August 5, 1988
C311-88-2103

Three Mile Island Nuclear Station, Unit 1 (TMI-1)
Operating License No. DPR-50
Docket No. 50-289
10 CFR 50 Appendix R
Loss of HVAC Additional Information

EMERGENCY FEEDWATER PUMP CUBICLE
Loss of HVAC
72 HR Temperature Projection

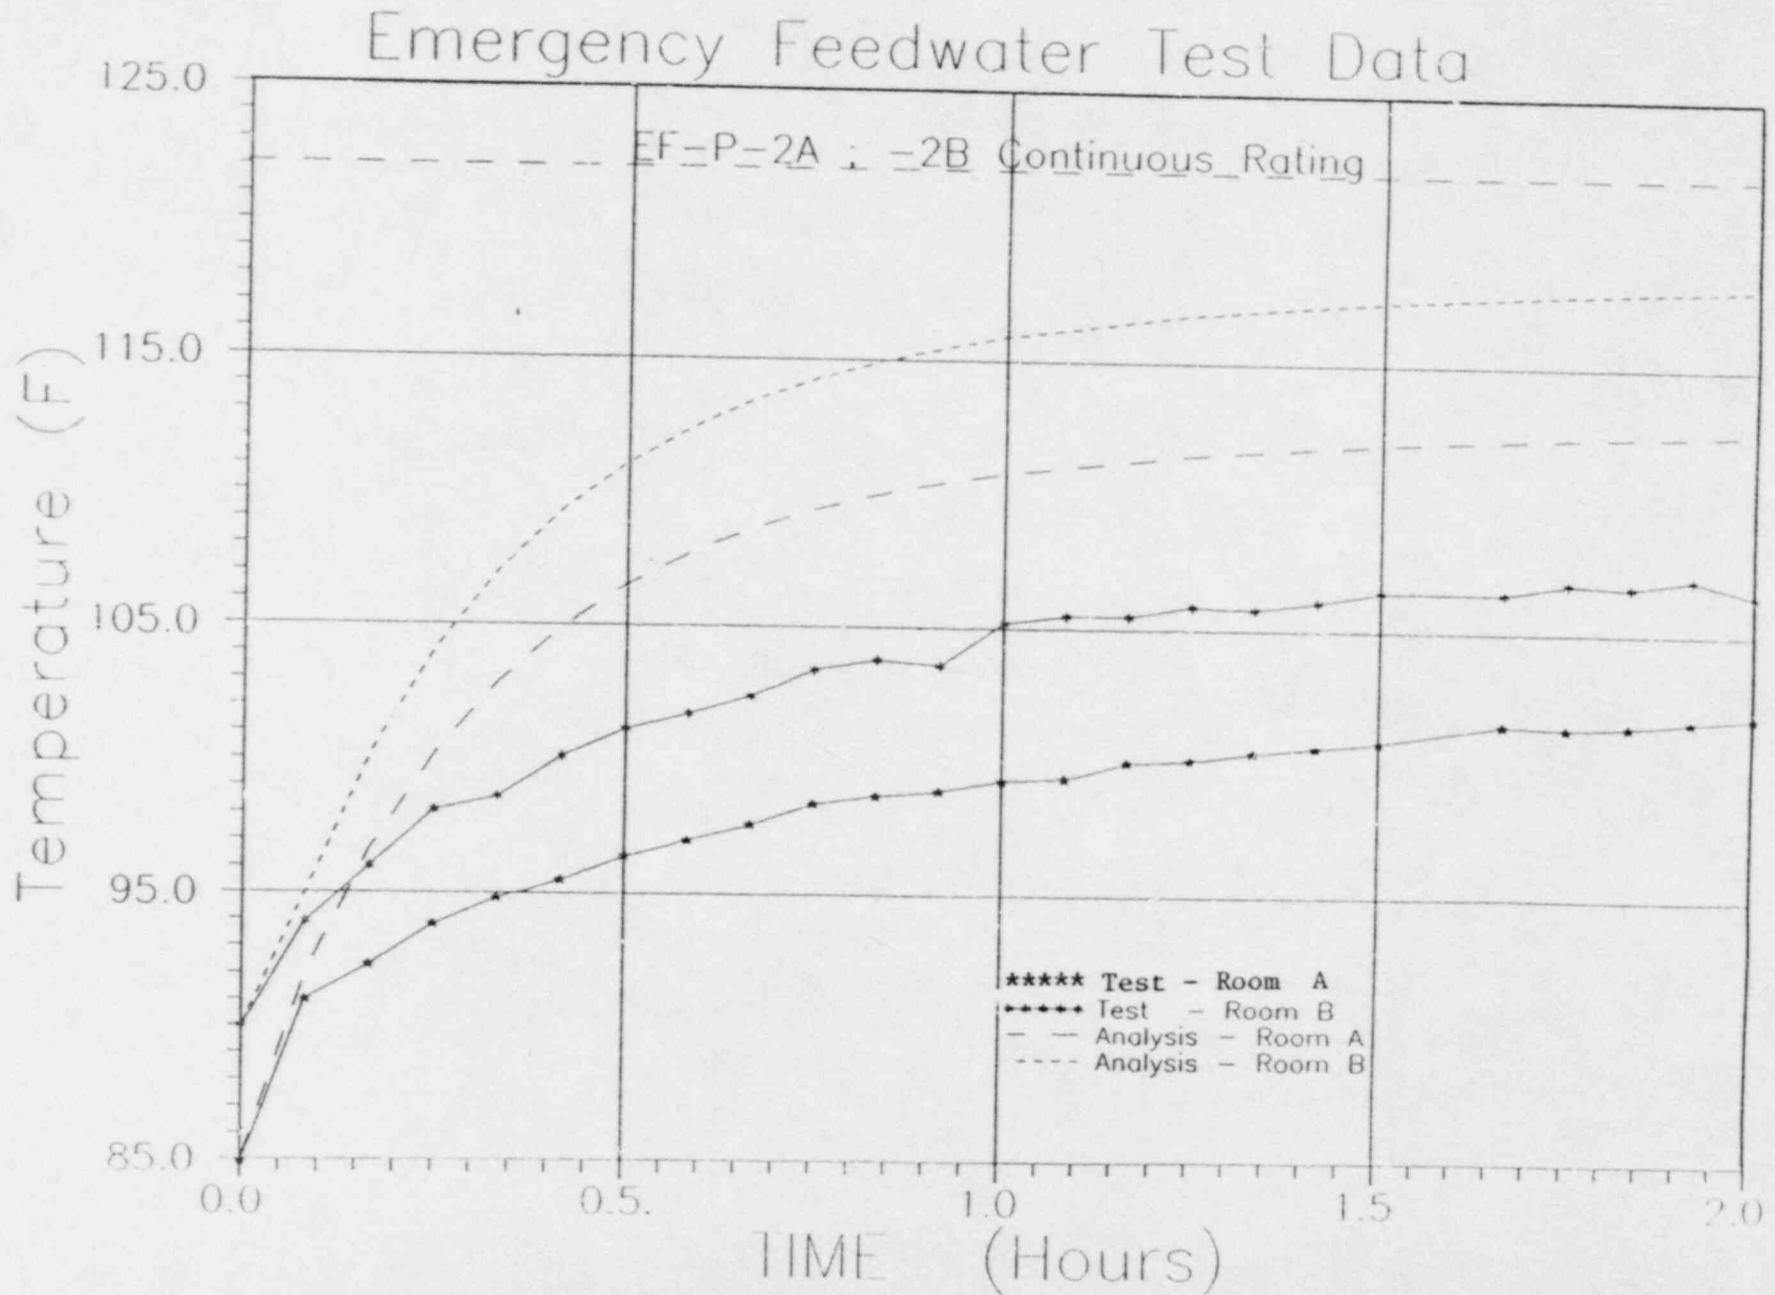
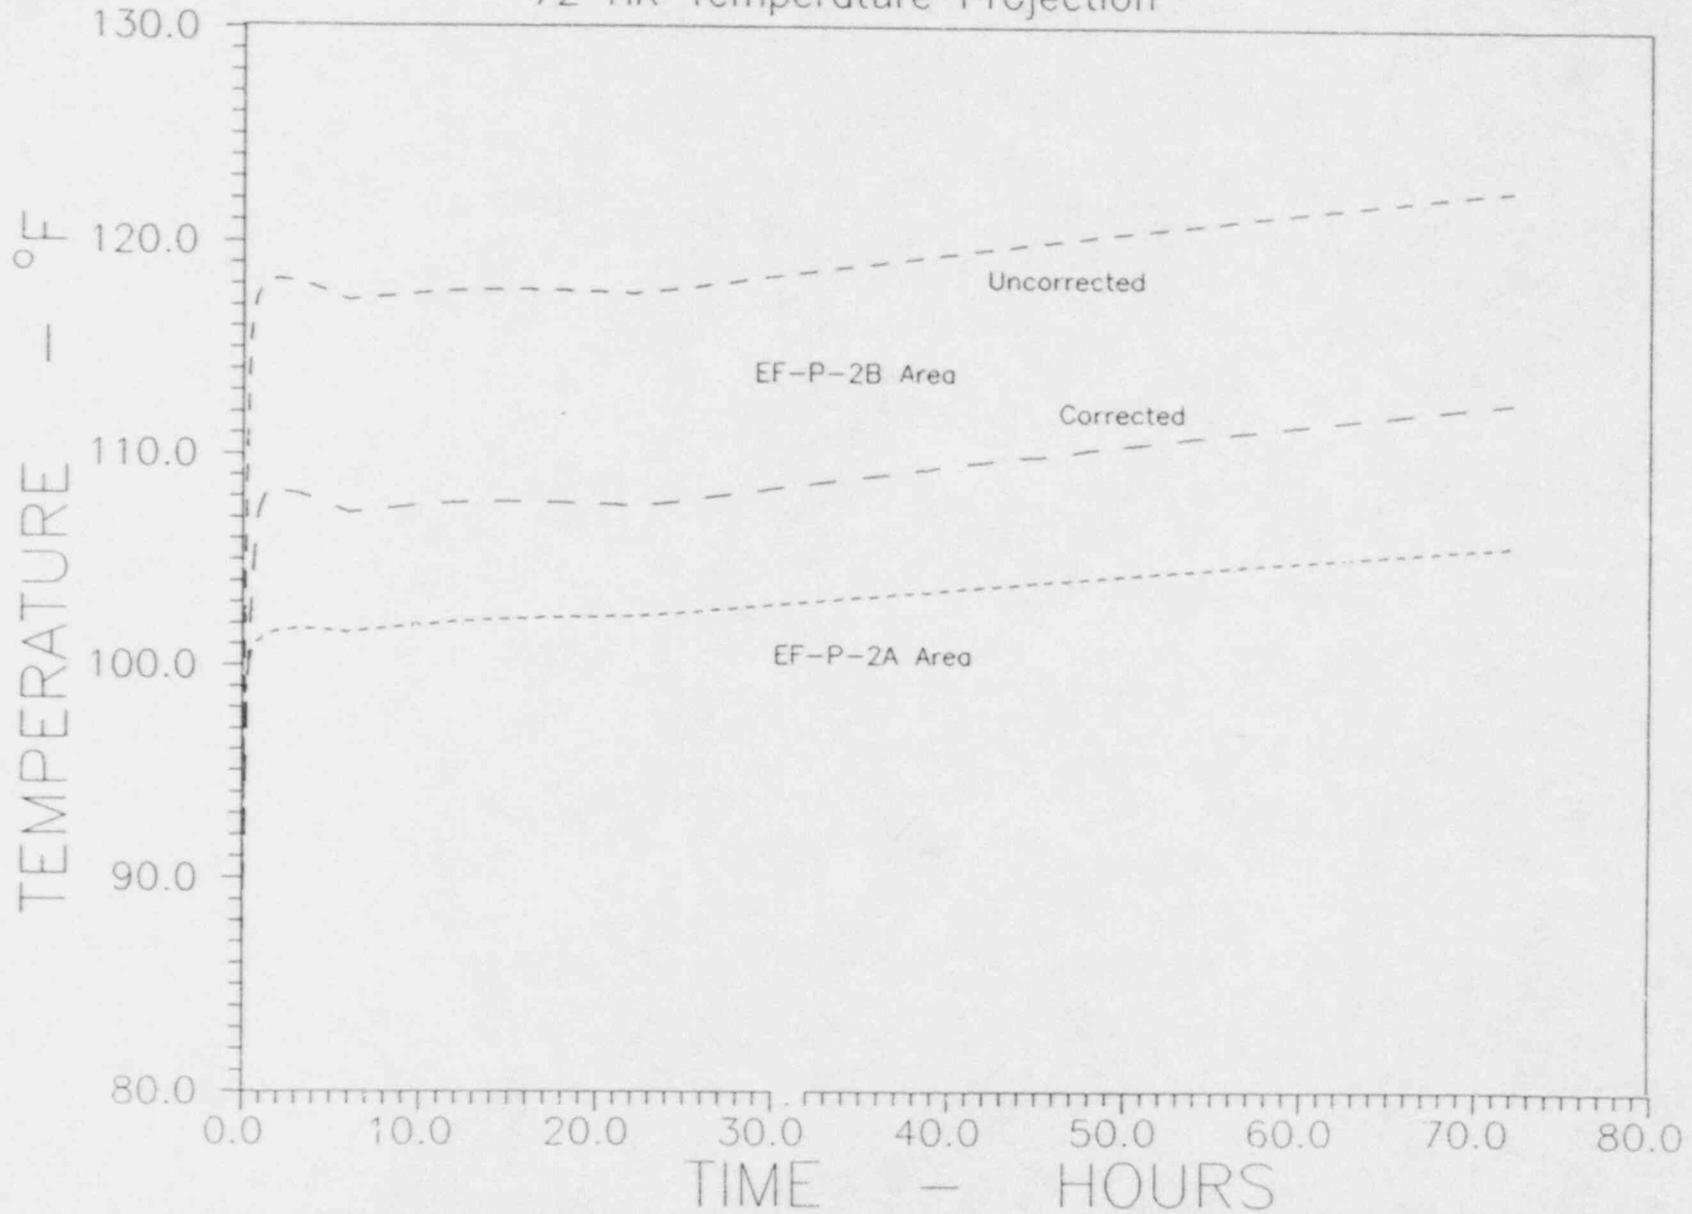
1. For the Emergency Feedwater Pump Room area clarify how it was determined that 113°F is the predicted maximum temperature. Provide an explanation of how the temperature profile curve was projected to go from the end point of the test data to 113°F (reference Figure 2 of May 5, 1988 submittal). Clarify the word "stabilized" used in the submittal.

2. For the Emergency Feedwater Pump Room area, assess the effect of the highest design river water and outside air temperatures. Assess end point/maximum temperature.

The predicted maximum temperature was determined by reviewing test data to determine the rates of rise for each room and from the understanding of the operation of the emergency feedwater pumps during shutdown. The use of the word "stabilized" generalized the characteristics of the test data for the individual areas and did not account for higher temperatures measured at the ceiling area. In reviewing the test data, there are at least three areas considered to have essentially stabilized in temperature: the EF-V-30B area, the operating air compressor area (non-essential component), and the hallway. The remaining areas are considered to be stabilizing based on their decreasing rate of rise over the two hour test period. This was not accounted for in the original submittal and the temperature curve assumed a level projection to 72 hours. The physical area has openings for natural convection to occur. Air flow due to natural convection would assist in the room reaching a stabilized temperature. However, an analysis has been performed to account for the varying heat loads in the room and component temperature variations.

The previous engineering conclusions have been evaluated through the use of additional analysis. The analysis concentrated on the motor driven feedwater pumps, since they have the lower continuous operating temperature limit of 122°F. A reasonable amount of natural convection was determined from the square footage of the openings in the area, the height difference between the openings and the expected temperature differential. The convective airflow is assumed to come from the hallway directly into the motor driven pump (MDP) room or through the compressor room. From a review of the pump flow rate requirements for the EFW pumps during shutdown, and from the pump performance curve, a profile of decreasing heat input to the pump room was developed. For the first five minutes, two MDP's are assumed to be on, one required and one spurious operation, with one pump deenergized after 5 minutes. From the five minute period to approximately 22 hours into the shutdown the EFW flowrate (and motor horsepower) is constantly declining. At 22 hours into shutdown a flowrate of approximately 100 gpm (240 bhp) is required which results in a 45 percent decrease in heat input to the space. This is reflected in the 0-22 hour time frame shown in Figure 2. The slope of the room temperature between the 5-1/2 and 22 hour time period is a product of decreasing internal load, concrete temperature, and convective air flow temperature. From a review of this curve, it is apparent that the heat removal capability of the concrete (due to its temperature at this time period) and convective air flow is almost equivalent to the decreasing heat input over the same time period. From 22 hours to 72 hours the heat input is constant and the concrete temperature is constantly rising due to the portion of room heat load it can absorb along with a rise in room temperature.

An analysis was run to try to simulate the test results. For the two hour period the analysis assumed that both MDP's and the air compressor were running. The analysis also used an air flow rate of 2000 cfm (1000 from the hallway, 1000 from the compressor area) to account for expected natural convection. These values were determined based on a calculation for flows due to thermal forces resulting in an air flow velocity of approximately 50 ft./min. through open passages. The results of this comparison are shown in attached Figure 1. As can be seen from this figure, the analysis profile is well above the actual test data but the profile of the analysis curve is very similar to the test profile. This represents the cumulative affects of the conservatisms in the analysis and the magnitude of the correction factor that can be applied. This is similar to the approach utilized in the control building.

Utilizing the inputs for decreasing motor heat loads as described above, in place of the EFW pump operational condition for the test, the analysis was run for 72 hours (Fig. 2). The correction factors determined from the analysis/test profiles (Fig. 1) must be subtracted from the 72 hour analysis profile. This correction factor is appropriate to apply to either pump provided it is in operation. For the EF-P-2A and the EF-P-2B pumps the correction factor for both pumps is 11°F. Since these curves are based on average temperature, the numerical difference between the average temperature and higher component temperature should be deducted from this correction factor. In both of the pump rooms this amounts to a 1°F deduction making the correction factor 10°F for the EF-P-2A and -2B pumps. Applying this correction factor to the end point temperature of EF-P-2B shown on the curve (Figure 2) yields a room temperature of 112°F. (The 2A pump is the pump that is deenergized at the five minute time period into the shutdown event.) A calculation was also performed to assess the effect on room temperature if operation of the second MDP continued for 12 hours. The result was a peak temperature in the "B" pump room of 117°F and a 72 hour temperature of 114°F. These temperatures are well below the continuous operating temperature limit of 122°F for these pumps. The above results are consistent with our previous statements that the EFW pump room temperature under realistic Appendix R shutdown conditions was expected to be lower than the room temperature profile based on the test data. These analytical results confirm that the previous extrapolation of test data was appropriate and that in all cases maximum expected temperature 72 hours after loss of HVAC are well within equipment operating limits.

Since no temperature limits for operation apply to the turbine driven (TDP) EFW pump and the MS-V-4B has a continuous operating temperature limit of 150°F, the MDP's are considered to be the critical area. Although the test temperatures were higher in the turbine driven pump room, more margin existed between the peak test temperature and the continuous operating temperature limit of MS-V-4B. The heat load in the MDP room is higher than for the TDP room which would result in a higher delta T from the initial temperature to the temperature at 72 hours. Based on the results provided in the analysis noted above no further investigation of the TDP room was made.

The Emergency Feedwater Pump Rooms located on the lower levels of the Intermediate Building are normally cooled by operation of one of the two installed air handling units (AH-E-24A, -24B). The design basis of these room coolers is to handle the heat loads generated during an emergency condition with EFW pumps operational. This design heat load is greater than the plant normal operating loads (EFW pumps non-operational). This ensures that the EFW Pump Room area initial temperature will not be significantly different from the test day temperature. During normal plant operation either air handling unit operates continuously in a complete recirculation mode and is isolated from the outside supply air. Due to the lack of introduction of outside air into the emergency feedwater pump rooms and the thick concrete construction of the Intermediate Building, variations of the outside ambient temperatures do not have an impact on the temperature in the EFW pump rooms themselves. Additionally, a large portion of the emergency feedwater pump area, the entire floor area, and at least ten vertical feet of wall area on three sides is in contact with the earth. This provides a significant heat sink since the temperature of the earth is essentially constant. This factor is a major contributor to maintaining the normal temperature in the EFW pump area relatively constant year round regardless of the outside ambient air temperature and nuclear services closed cooling water (NSCCW) (water source to the coils installed in AH-E-24A, -24B) temperature. Based on the history of the NSCCW temperature, it is estimated that at the time of the test the cooling water temperature was approximately 80 - 85°F while the maximum temperature could be as high as 90°F. The higher cooling water temperature will cause the air supply temperature from the air handling unit to increase an equal amount. However, the resultant room temperature will not increase by the same amount since a higher temperature in the space provides a greater temperature differential to the heat sinks and a lower differential to the heat producers (heat out increases while heat in decreases). Therefore, the temperature of the EFW pump area at the start of the test is approximately the same initial temperature that would normally exist even with higher outside ambient air temperature and NSCCW temperatures to the air handling units. Accordingly, it is concluded that the temperature profile for the EFW pump room will not change due to variations in outside ambient effects, and there is no impact on the expected maximum room temperature 72 hours after loss of HVAC.

NUCLEAR SERVICES PUMP CUBICLE
(Ventilation in Operation) - Test Data

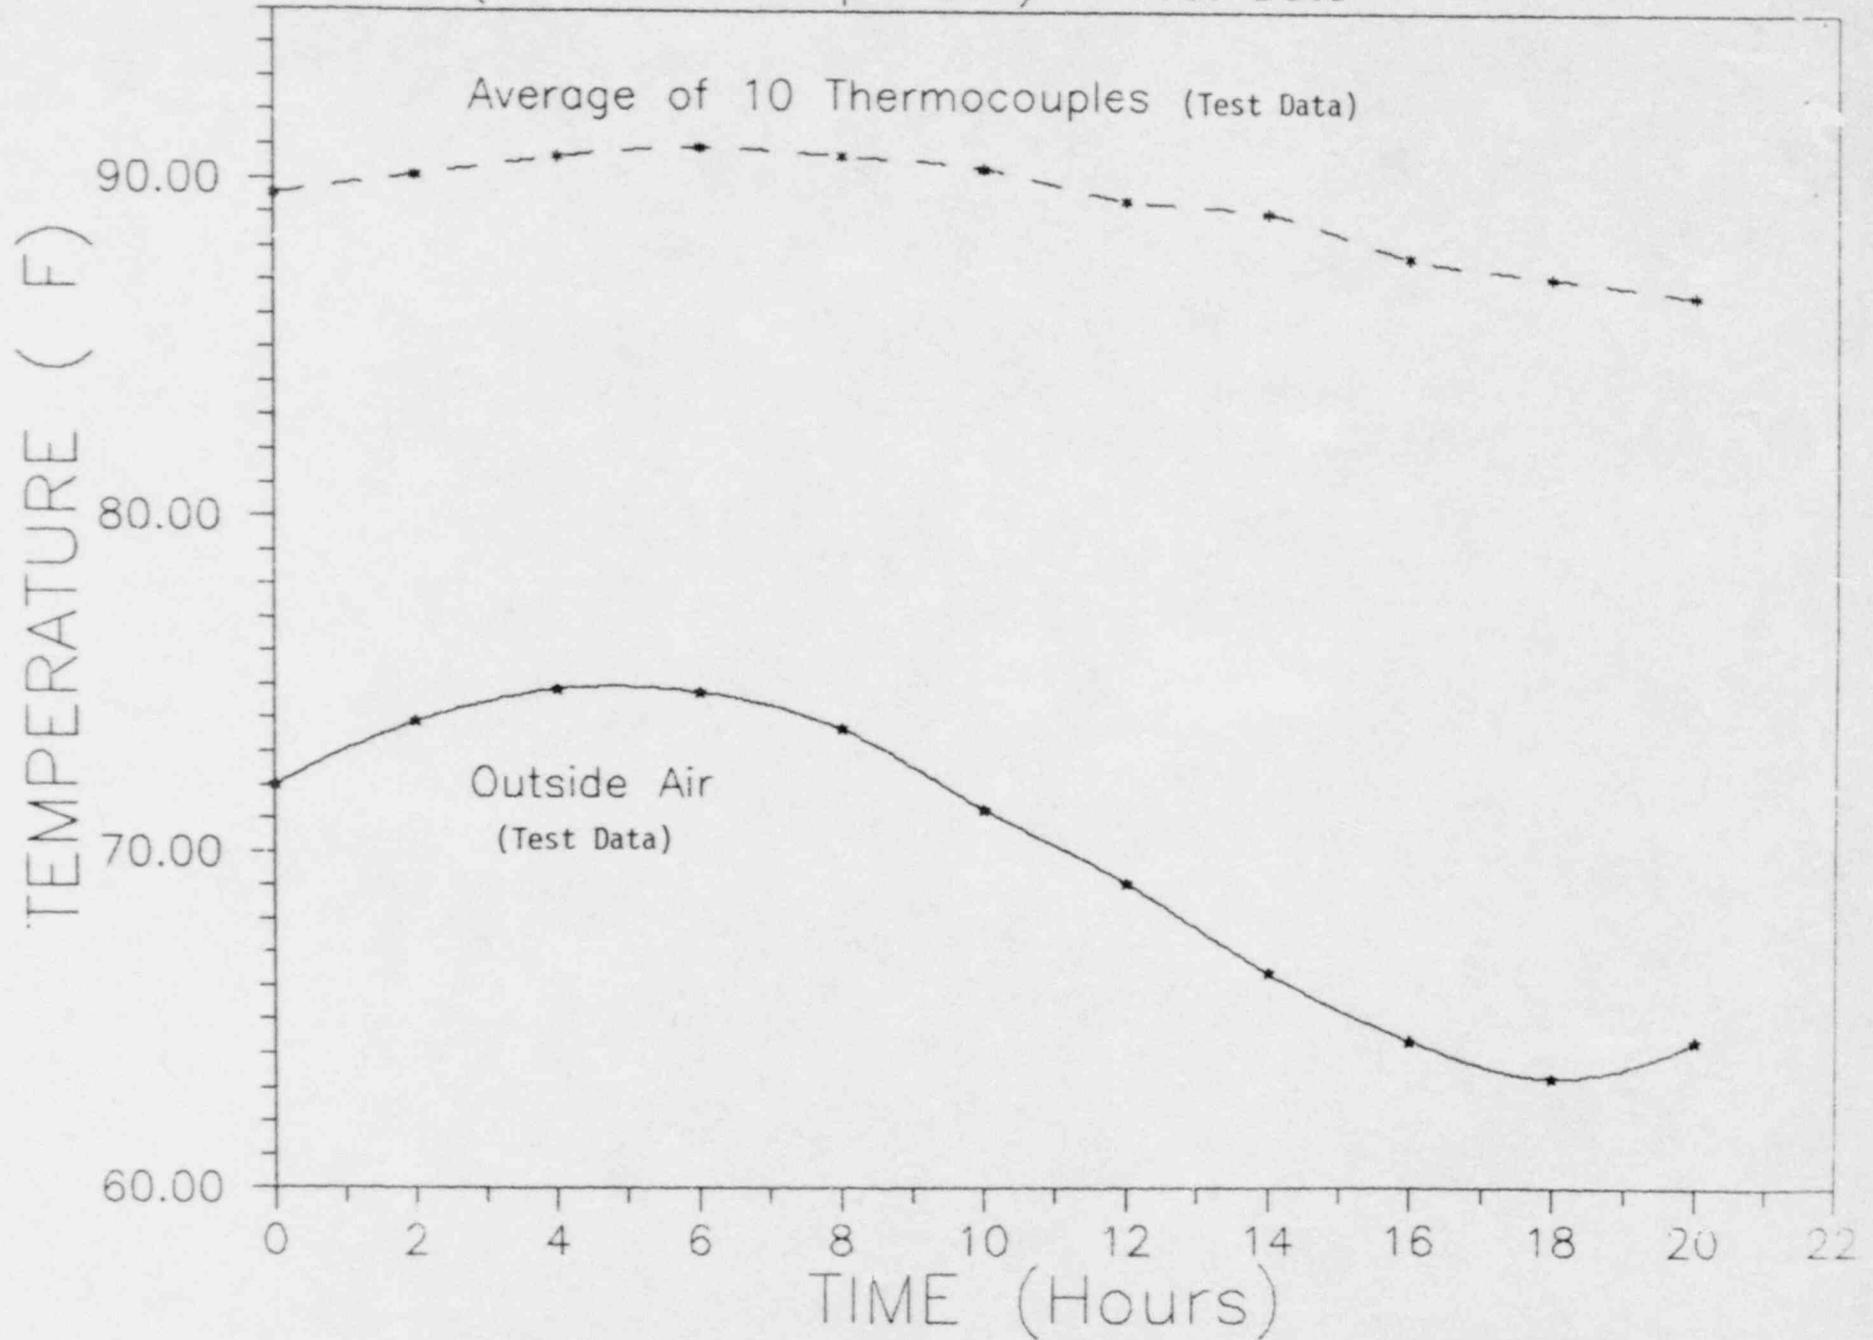
3. For the Nuclear Services Closed Cycle Cooling Water (NSCCW) Pump Room area, assess the effect of the highest design river water and outside ambient air temperatures on the end point/maximum temperature. Also, confirm that heat removal of cooling water does not outweigh the additional heat input due to the third pump running.

During normal plant operation the nuclear services pump cubicle (NSPC) is ventilated via a dedicated air handling unit (AH-E-15 A or B) and air provided from the Auxiliary Building (through ducted exhaust from the cubicles with makeup through the opening in the southeast corner of the zone). The amount of air contribution from the Auxiliary Building accounts for approximately 27% of the total airflow in the pump cubicles. A comparison of test day temperature changes indicates a min. to max. recorded outside air = $\Delta 11.6^{\circ}\text{F}$ and NSPC = $\Delta 4.4^{\circ}\text{F}$. A review of the test data taken prior to the loss of ventilation test demonstrates the relationship between outside air temperature and the ambient temperature of the nuclear services pump cubicle (see Figure 3). The average NSPC temperature at time = 0930 was not included in this evaluation since all ten (10) thermocouple readings dropped in temperature ($0.5^{\circ} - 4^{\circ}\text{F}$) which is inconsistent with previous data, or when comparing it to the outside air temperature which rose 6.8°F in the same time period. The location of the thermocouples contributed to a slightly depressed average temperature in the pump cubicle area. At least four (4) of the ten (10) thermocouples were away from heat producing equipment and were influenced by the air contribution from the Auxiliary Building to a greater extent. The average pump cubicle temperature prior to loss of ventilation on the test day was $87-91^{\circ}\text{F}$. The NSCCW temperature to the air handling unit coolers was approximately $85-90^{\circ}\text{F}$ during the test resulting in an initial temperature in the NSPC close to an expected maximum. After loss of ventilation, there is no introduction of outside air. Recent data taken outside the NSPC with ventilation operating indicated a temperature of 90°F with outside air temperatures of approximately 100°F . This demonstrates significant heat sinks are available on the 305' elevation of the Auxiliary Building which are capable of maintaining cooler temperatures during mid-summer peak temperatures. The Auxiliary Building minimum supply air temperature is controlled through the use of resistance heating to maintain a minimum building temperature of 65°F . This results in an Auxiliary Building elevation 305' temperature variation of approximately 25°F year round. Applying the NSPC percentage temperature deviation when compared to Auxiliary Building 305' temperature results in a temperature variation in the nuclear services pump cubicle of only 9°F . The NSPC temperature is primarily controlled by the operation of the dedicated air handling units (AH-E-15 A or B) with its supply air temperature dependent on the temperature of the nuclear closed cooling water (provided to cooling coils). The small deviation in temperature in the nuclear services pump cubicle provides a nearly constant initial temperature when loss of ventilation must be considered. Therefore, the predicted maximum temperature of 99°F is reasonable based on the review of existing test data. It is realized that the outside air temperature for the time period prior to the loss of ventilation was below normal for that time of

year. As noted before, this did not have a significant effect on the initial ambient temperature of the NSPC. It did have an effect immediately after the initiation of the loss of ventilation since a cooler source of air from areas outside the pump room was available to the pump room through natural convection. The result was a dip in localized temperatures until the thermal differences (air temperatures) between the pump cubicle and the area outside the pump cubicle achieved uniform mixing. Higher initial Auxiliary Building temperatures (such as 90°F) would have created a smoother room profile since the temperature differences between the two areas would not be as dramatic. It is not considered to have an effect on the predicted maximum temperature.

It should be noted that during the NSCCW test, an extra Nuclear Services pump was in operation which contributed higher internal heat load. When comparing the heat contribution from the motor and the potential cooling affect of the associated piping, there is a resultant increase in heat load of approximately 25,000 BTUH compared to the total heat load of 100,000 BTUH. This supports the previous conclusion that the heat load into the pump cubicle during the test bounds the actual heat load during an Appendix R shutdown event.
